Application Number P24-12

P24-12 REVISED Lafayette Road Addition and Detached Garage

Location: 455 Lafayette Road

Request: Revised approval for an addition and garage in the TC-OV District

East Elevation

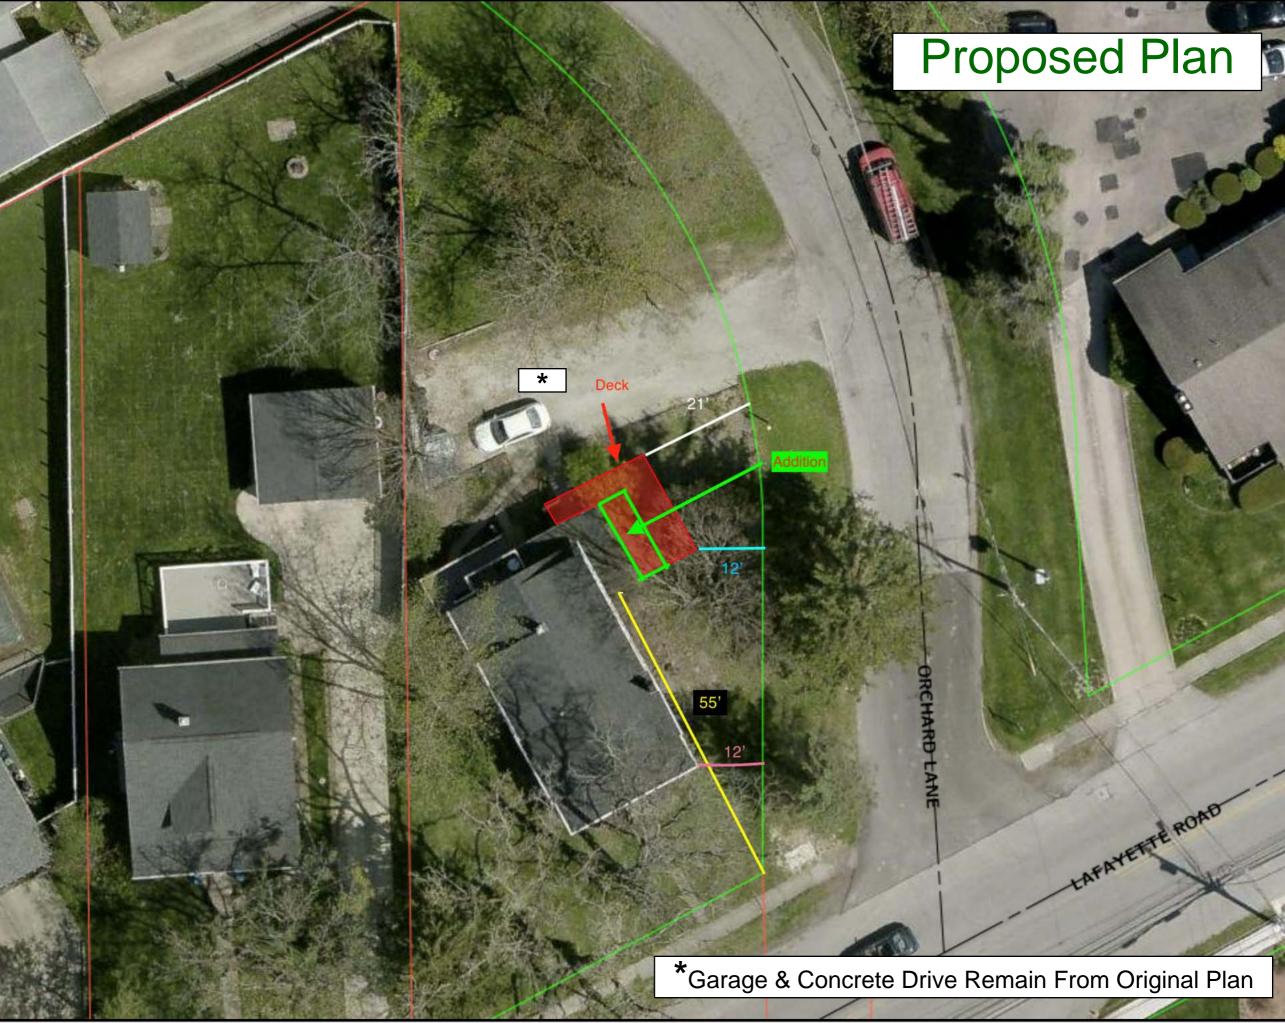
A one-story enclosed porch is located on the east side of the existing structure. The porch is proposed to be removed and replaced with a two-story addition and deck. The first floor of the addition will have double doors opening to the proposed deck, though the second floor will not have features facing Orchard Lane.

Staff recommends **approval** of revised application P24-12, with the condition that a feature(s) be incorporated on the east side of the addition's second floor such as a window, alternative material, design element, or similar item.
